# METROPOLITAN GOVERNMENT OF NASHVILLE AND DAVIDSON COUNTY

## STAFF RECOMMENDATION

1413 Russell Street  
January 18, 2012

**Application:** Infill

**Right Elevation - 1413 Russell**

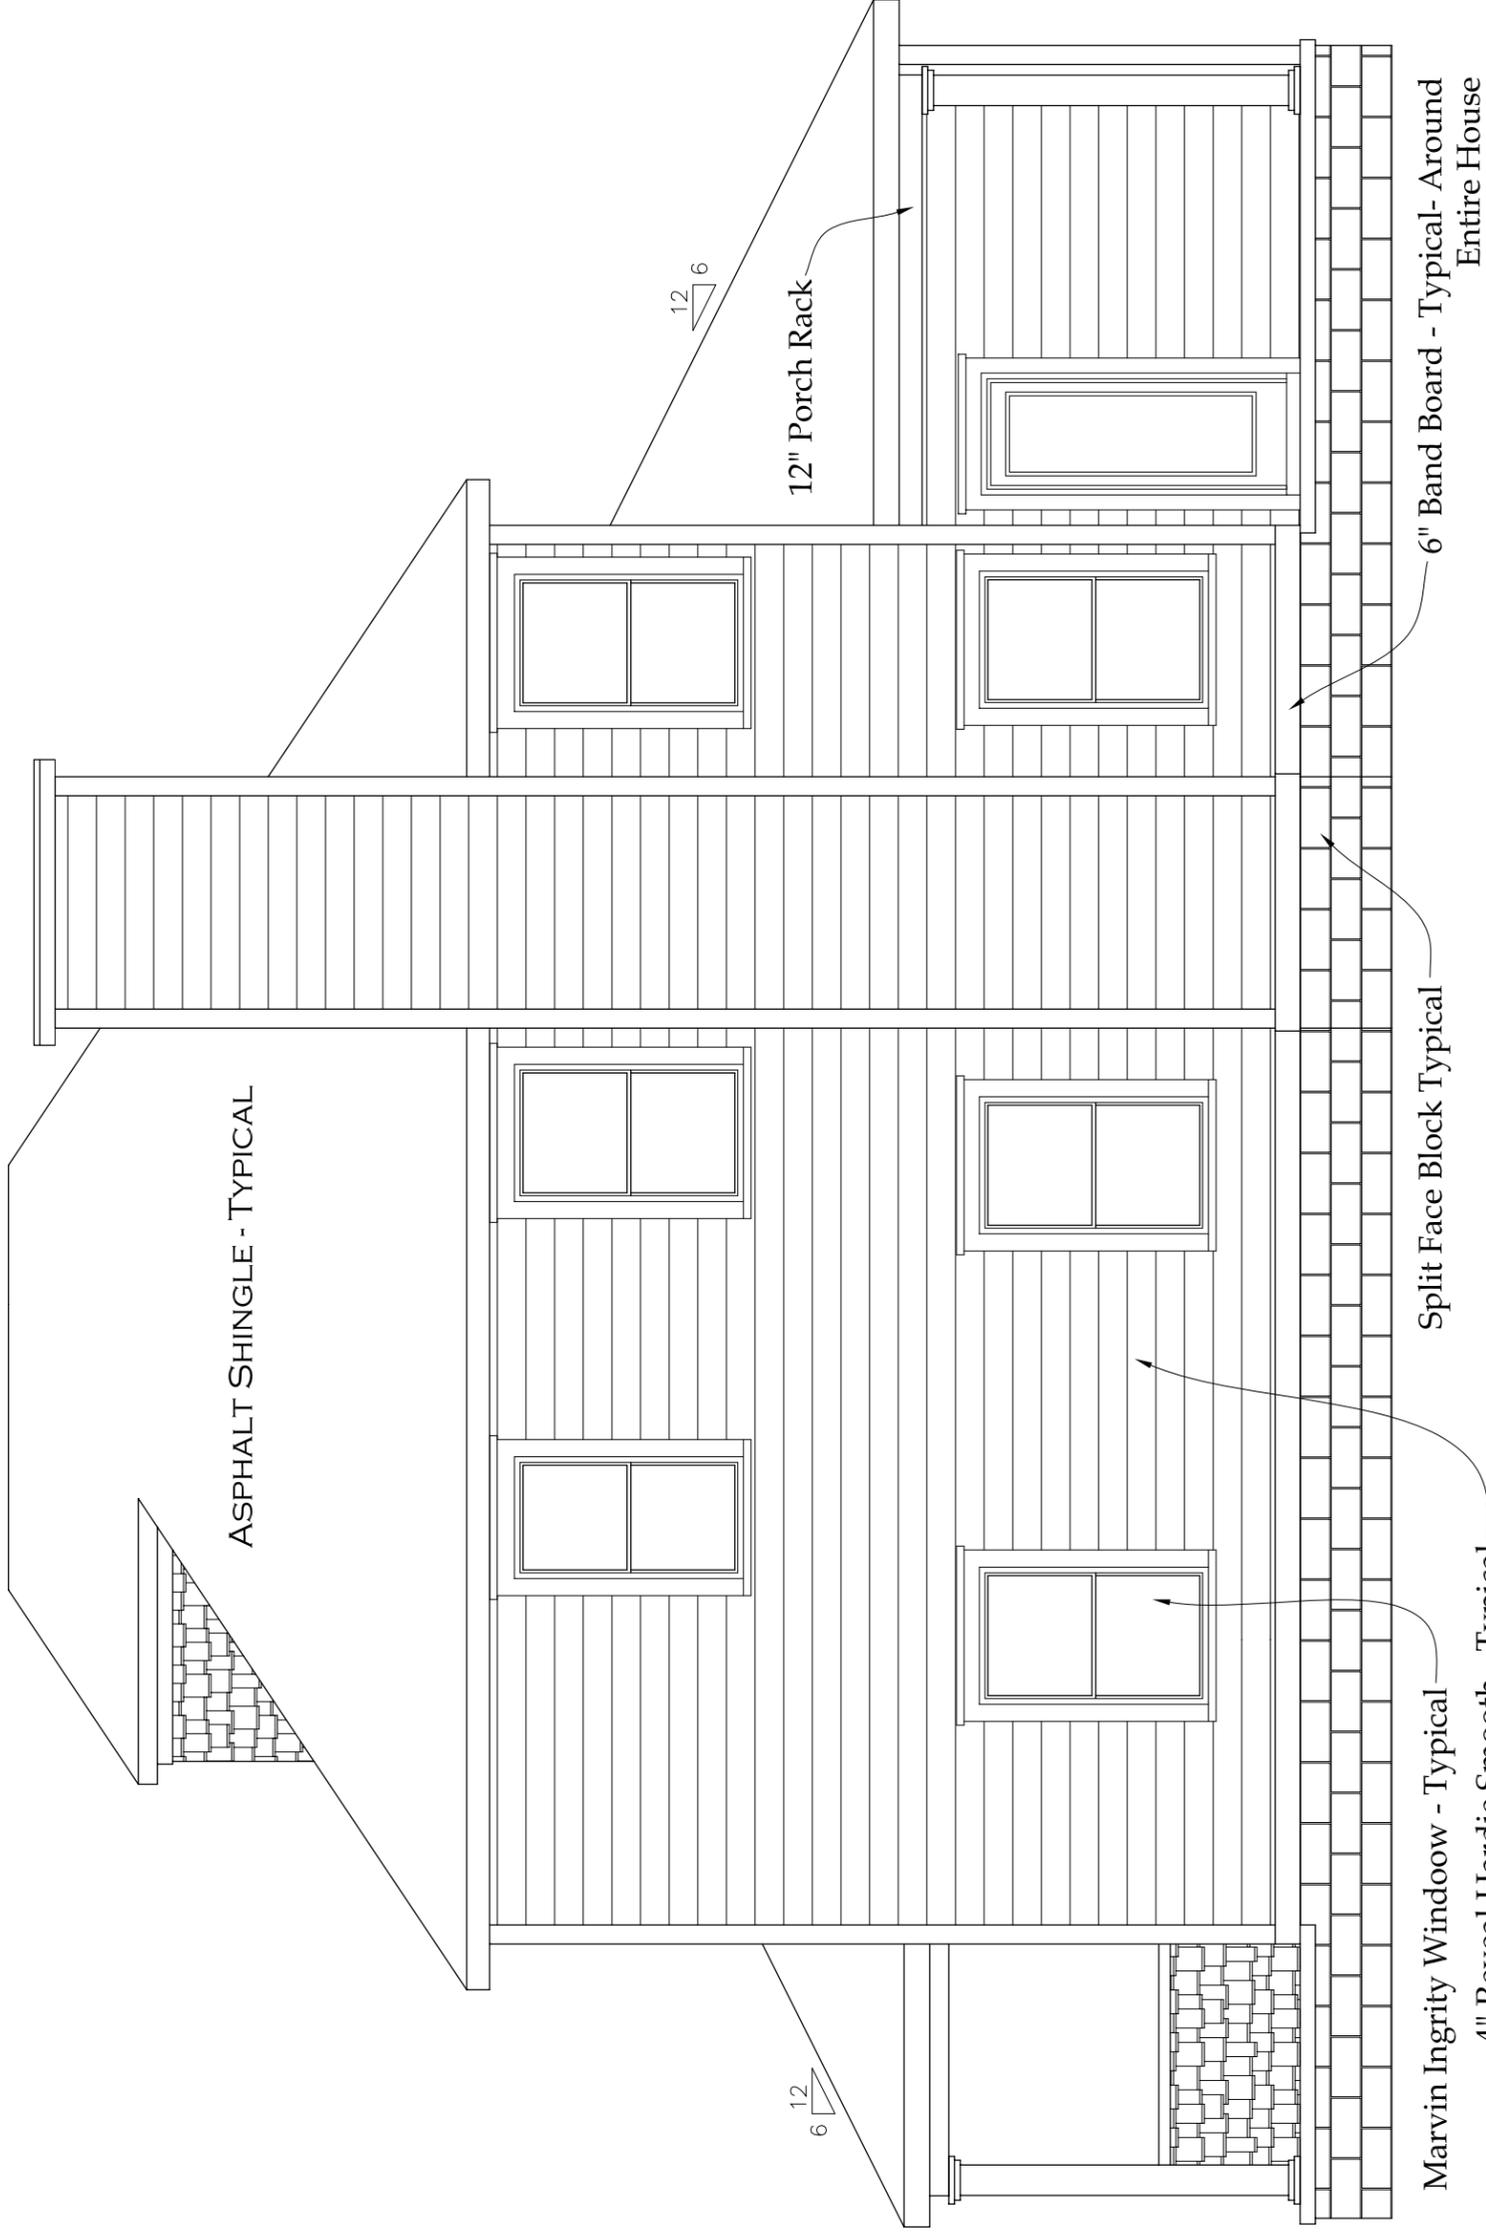
The plans show a thirty-foot tall clapboard-sided chimney on the right elevation. Historically, chimneys have been constructed of brick or stone. Staff recommends that the chimney be masonry, actual or veneer, or that it be shortened to resemble a “box-bay” if it does not need to be vented.
